**THE ROVER COMPANY LIMITED**

## LAND-ROVER SERVICE NEWS LETTER No. 41

February, 1964

Fig. 1

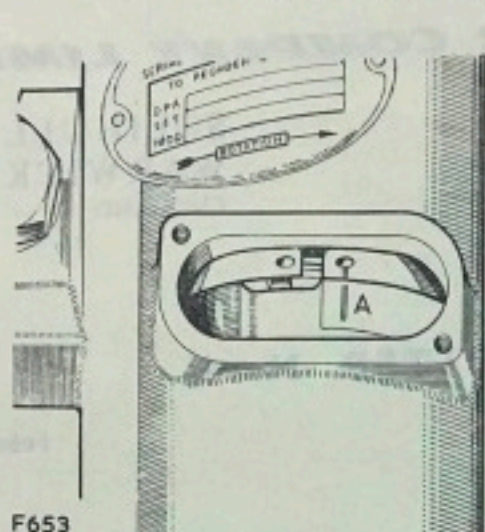
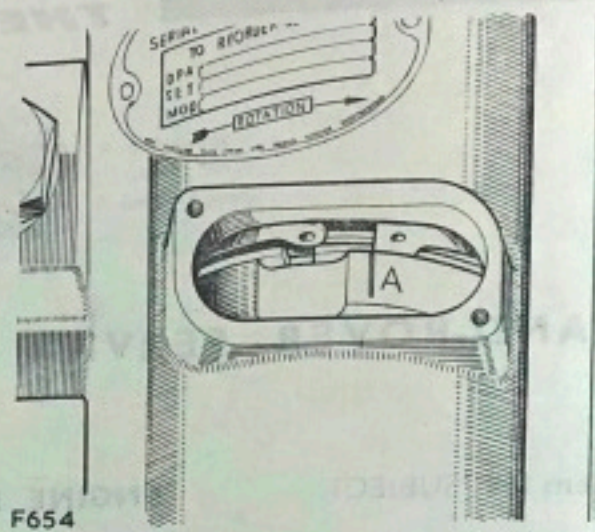
**MODIFICATION:** The timing circlip on the distributor pump has been altered from a round eye to a straight edge on one side. See illustrations below.

1. Align the appropriate timing mark on the flywheel with the pointer as detailed in the Land-Rover Workshop Manual.
2. Remove the inspection cover from the injection pump and rotate the spindle until the line marked 'A' on the driving plate is aligned as follows:
  - (a) Early models: Mark on timing circlip.
  - (b) Late models: Straight edge of timing circlip.
3. Offer the pump to the engine and engage in the splined shaft. With a small mirror, observe the setting through inspection aperture in injection pump and make any final necessary adjustment by turning the pump body to align the timing circlip as detailed above.

Hold the pump drive plate and press the skew drive gear back against the driving side of the teeth whilst final adjustments are made and the pump secured, in order to avoid any timing errors.
4. Recheck the timing by turning the crankshaft in the direction of rotation until both valves of number one cylinder are closed and the piston is ascending the bore on the compression stroke, continue to turn the crankshaft slowly. With a small mirror observe that the timing mark 'A' on the pump drive plate aligns as follows:—
  - (a) Early models: Mark on timing circlip.
  - (b) Late models: Straight edge of timing circlip.
